**Field House.
Dewsbury.**
Mood Developments Ltd.

ACOUSTICS

STAGE 3 DESIGN REVIEW

REVISION 00 – 09 SEPTEMBER 2021

Figure 3 Proposed new-build timber floor build-up between apartment units

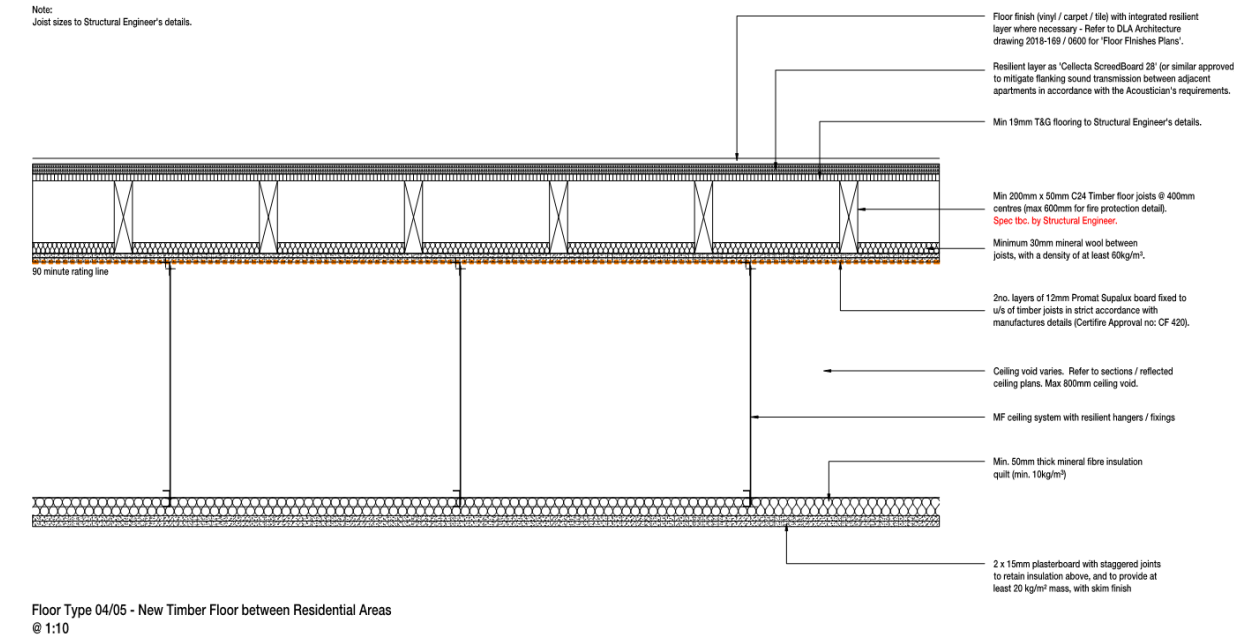
The proposed floor build-ups are presented in Figure 3 and Figure 4, both extracted from proposed floor build-up drawing 2018-051_0311, dated 18/08/2021.

The proposed build-ups presented above are anticipated to be capable of achieving the requirements of ADE for both airborne and impact noise transmission across party floors.
